MEMORANDUM

DATE: JANUARY 21, 2015

SUBJECT: 5th CONCEPT REVIEW OF 2 DUKE STREET
(FORMERLY ROBINSON TERMINAL SOUTH)
BAR CASE # 2014-0113

BAR Work Session No. 5 Submission

BUILDING 03 PLAN COMPARISON

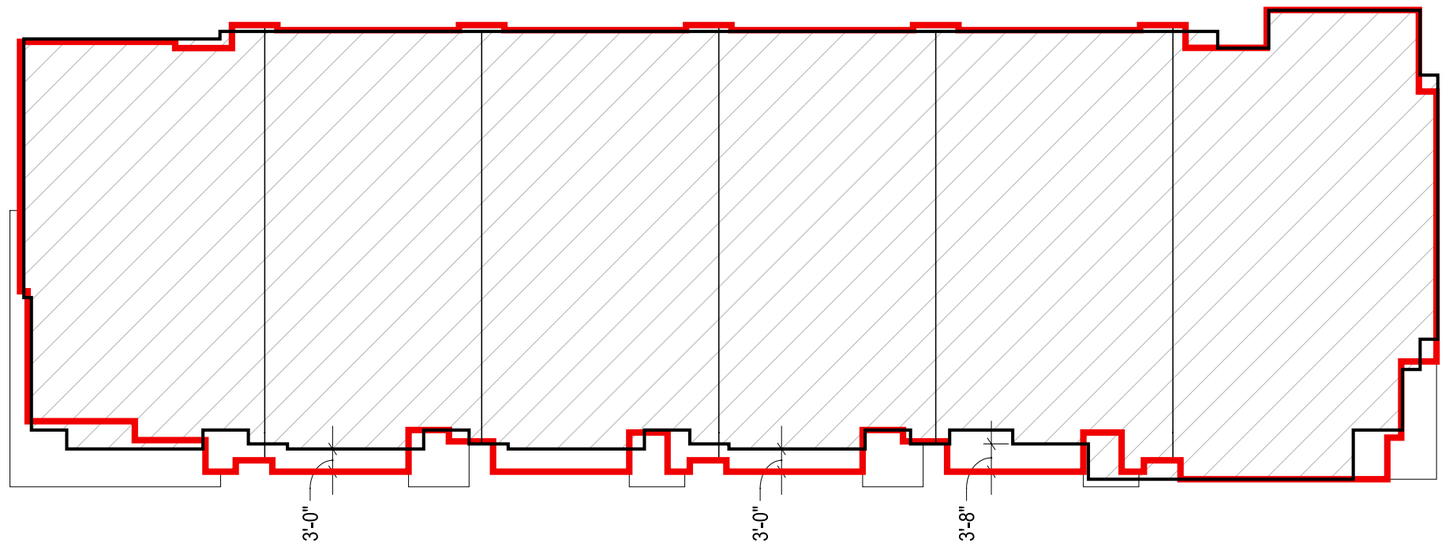
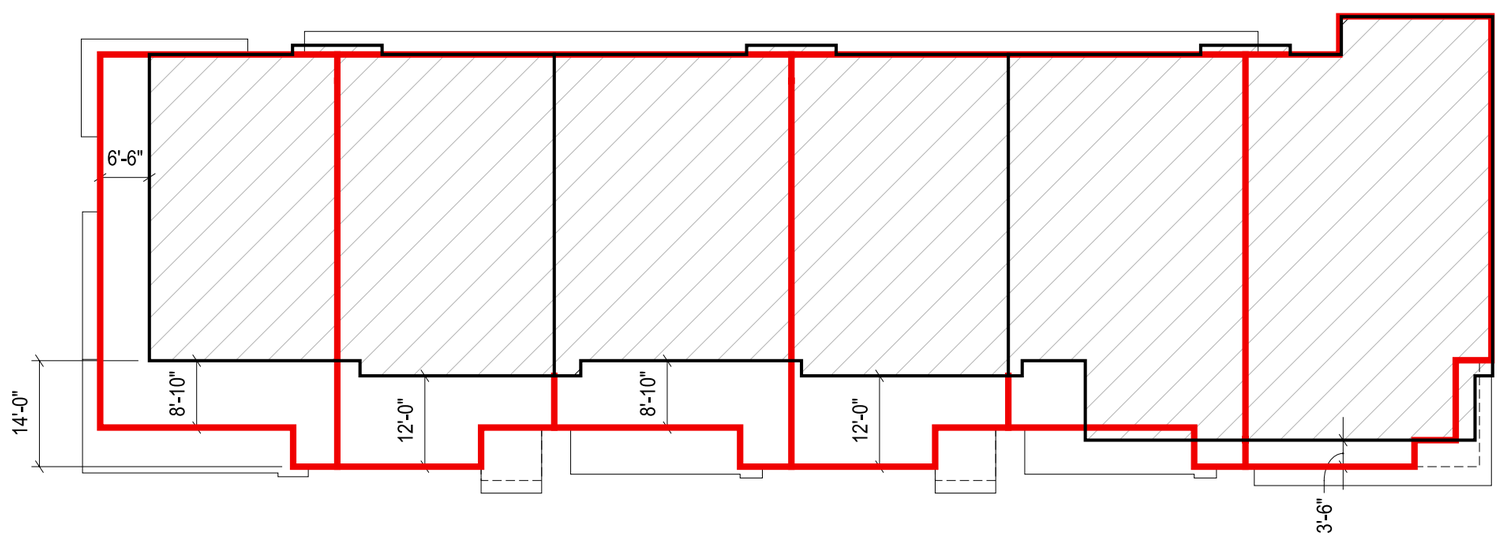
Additionally, the scale of Building #3 has been entirely changed as there is a clear and physical break above the third story (see Building #3 Plan Comparison on Sheet 14). This is achieved by a set back at the fourth story (3') and an even greater set back (ranging from 8'- 10" to 12'- 0") at the fifth story on Wolfe Street. Since the last iteration, presented at work session #4, there has been no increased set back at the fourth story on South Union Street and at the fifth story the set back is 6'- 6". Staff notes that the shift in scale and architectural form is more successful on Wolfe Street and clearly addresses the setback requirements of the Potomac River Vicinity Height District. The combination of the increased upper floor set backs and incorporation of a townhouse rhythm and scale generally results in a much more balanced and appropriate building for this particular location. As this building will be experienced on all four sides, there is also a greater cohesion to the building among all four elevations.

However, to improve the overall cohesion of the building and to improve the transitional relationship with the adjacent block faces, staff recommends that meaningful set backs be added on South Union Street, proportionally similar to what the applicant has done on Wolfe Street. This upper level setback is particularly important on the west end of Building #3, as South Union Street is only 50' wide, where Wolfe Street is a 66' right of way more typical of historic Old Town.

At this time, staff recommends that the Board find that the height, scale, mass and general architectural character of the overall project are appropriate and endorse the project for review by the City Council with the condition that increased fourth and fifth story set backs be employed on the west elevation of Building #3 on South Union Street, similar in scale to those shown on Wolfe Street, and that additional interpretation of the site and waterfront history be incorporated prior to application for Certificate of Appropriateness.
